- 3. Ninilchik Townsite Vane 2023 Replat
KPB File 2022-182
Peninsula Surveying LLC / Vanek
Location: Bayview Street & Mission Avenue
Ninilchik Area**

ITEM 3 - NINILCHIK TOWNSITE VANEK 2023 REPLAT

KPB File No.	2022-182
Plat Committee Meeting:	January 23, 2023
Applicant / Owner:	Betsy and Rion Vanek of Ninilchik, Alaska
Surveyor:	Jason Schollenberg / Peninsula Surveying, LLC
General Location:	Mission Avenue, Bayview Street, Ninilchik area

STAFF REPORT

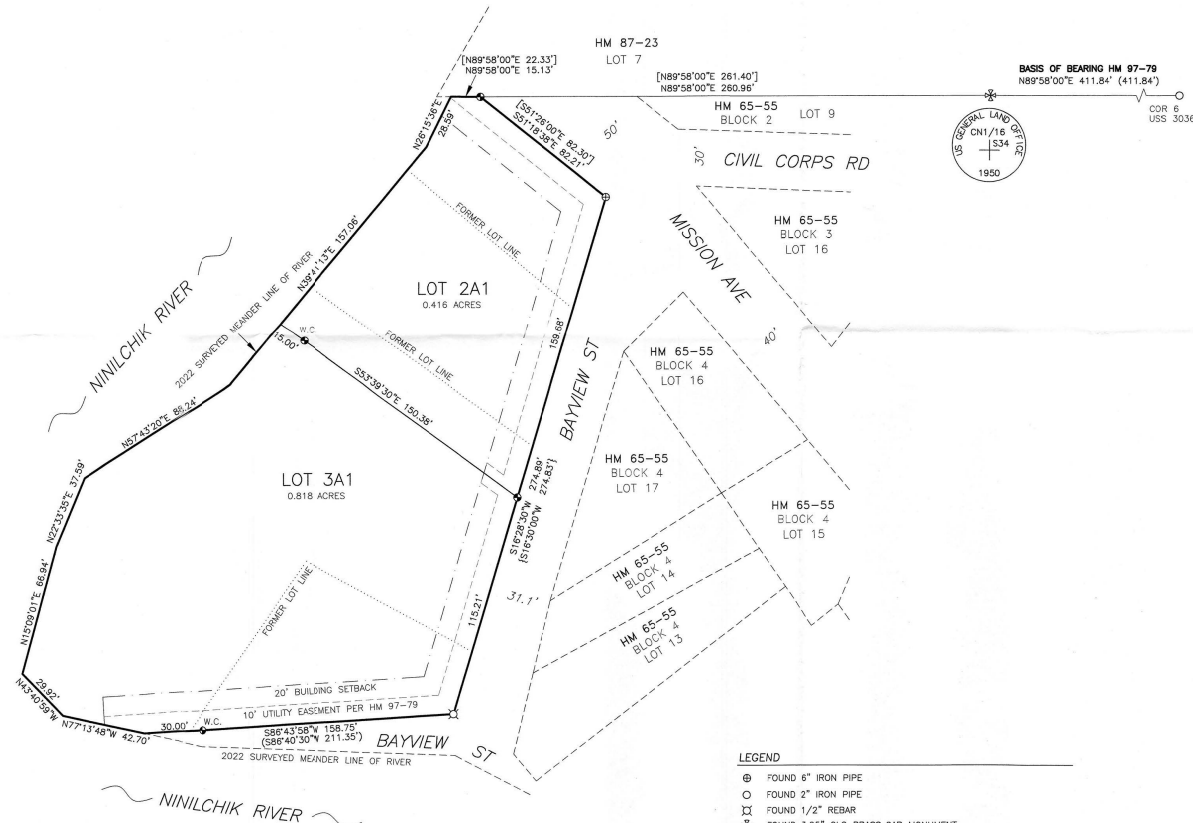
Site Investigation: While no obvious wet areas are present, the entire subdivision is within a wetland assessment area. Portions along the southwest are considered tidal and the remaining is riverine. The note to have a wetland determination is present. **Staff recommends due to the entire subdivision containing areas designated as wetlands, the depiction is not required on the final but the plat note should remain.**

The property shows the 2022 surveyed meander of the Ninilchik River. **Staff recommends the source or method for finding the meander should be noted or provided within a note, and a note regarding natural meander is for computations only should be added.**

The proposed subdivision is within multiple Flood Hazard Zones. The majority is within X which is minimal risk and is non-regulatory. Portions within the western and southern areas are within AE zone. The AE zone is regulatory and has a 1% annual chance of flooding. **Staff recommends the AE zone boundary be shown on the plat and the required flood hazard note be added.**

The Ninilchik River is an anadromous stream. **Staff recommends the anadromous waters habitat protection district note is required to be added.**

There are multiple structures on the property. It appears the removal and movement of lot lines will fix any encroachment issues within the subdivision boundary. Per KPB GIS Imagery, there may be a structure within the Bayview Street dedication. Additionally, some of the structure may be close to the building setbacks and utility easements. Parent Lot 1 was not subject to a setback or platted utility easement until this plat is recorded. The remainder of the subdivision had setbacks put into place with Ninilchik Townsite Jackinsky-Vanek Replat, HM 97-79. If it can be proven buildings existed prior to setback creations plat notes may be added that they are exempt. **Staff recommends all structure locations be verified, if any permanent structures are found within the rights-of-way, setbacks or utility easements additional requirements or notes may be required, if no encroachment issues are found this should be disclosed in writing.**

Per the Certificate to Plat there is a cabin on the property that was sold. There is no mention if the cabin was to be later relocated or what the access rights are to the cabin. **Staff recommends if the cabin is still present to depict on the plat with a reference to a plat note with the information regarding the sale of the cabin.**

An easement for a leach field is shown on the Certificate to Plat. The easement affects Lot 3A Block 5. This easement is for the benefit of Lot 13 Block 4. **Staff recommends a plat note be added with the information regarding the easement.**

Utility Easements A recorded easement to ACS is within the Certificate to Plat. The easement is within parent Lot 1. The easement states the location and it should be depicted on the final plat. This plat will be granting utility easements along the rights-of-way for those not previously granted. If it is found that the ACS easement will be within a new or already granted utility easement it does not require depiction but a reference to a plat note. **Staff recommends a plat note be added with the information regarding the ACS easement and if within another existing easement state as such.**

Parent lots 2A, 3A, and 4A had 10 foot utility easements granted along the rights-of-way that increased to 20 feet within 5 feet of the side lot lines. Parent Lot 1 does not have any platted easements to carry over. **Staff recommends the depiction of the utility easements be updated to include the 20 feet within 5 feet of the former side lot lines as they apply.**

This plat is proposing to grant 10 foot utility easements that increase to 20 feet within 5 feet of the side lot lines. These are depicted and noted on the plat. **Staff recommends** the portion of the utility easement within parent Lot 1 should include "granted by this plat".

*Update the plat note numbers.
Add KPB number*

- G. The status of adjacent lands within 100 feet of the proposed subdivision boundary or the land status across from any dedicated rights-of-way that adjoin the propose subdivision boundary, including names of subdivisions, lot lines, block numbers, lot numbers, rights-of-way; or an indication that the adjacent land is not subdivided;
Staff recommendation: *Provide a width label for the portion of Bayview Street located south of the plat even though the river takes up a portion.*

- H. Approximate locations of low wet areas, areas subject to inundation, areas subject to flooding or storm water overflow, and the line of ordinary high water. This information may be provided on an additional sheet if showing these areas causes the preliminary plat to appear cluttered and/or difficult to read;
Staff recommendation: *Not shown. The entire subdivision is low wet areas and within a floodplain. Notes will be required.*

- J. Block and lot numbering per KPB 20.60.140, approximate dimensions and total numbers of proposed lots;
Staff recommendation: *Include a block label within the lots to carry over the block designation.*

- N. Apparent encroachments, with a statement indicating how the encroachments will be resolved prior to final plat approval;
Staff recommendation: *Verification of structure locations will be needed.*

Staff recommendation: Block label needed.

- *“No access to state maintained rights-of-way permitted unless approved by the State of Alaska Department of Transportation.”*
- **FLOOD HAZARD NOTICE:**
Some or all of the property shown on this plat has been designated by FEMA as a flood hazard area district as of the date this plat is recorded with the district recorder's office. Prior to development, the Kenai Peninsula Borough floodplain administrator should be contacted for current information and regulations. Development must comply with Chapter 21.06 of the Kenai Peninsula Borough Code. Map panel 02122C-1620E.

- **ANADROMOUS WATERS HABITAT PROTECTION DISTRICT NOTE:**
Portions of this subdivision are within the Kenai Peninsula Borough Anadromous Waters Habitat Protection District. See KPB Chapter 21.18, as may be amended, for restrictions that affect development in this subdivision. Width of the habitat protection district shall be in accordance with KPB 21.18.040.

- *Subject to an easement for leach field access as recorded on November 23, 2020 as serial number 2020-004045-0, HRD.*
- *A cabin located on parent Lot 3A Block 5, Ninilchik Townsite Jackinsky-Vanek Replat, Plat HM 97-79 had title severed by a Bill of Sale recorded on September 23, 2022 as Serial Number 2003-004786-0, HRD.*

- *The natural meanders of mean high water line is for area computations only, the true corners being on the extension of the sidelines and the intersection with the natural meanders.*
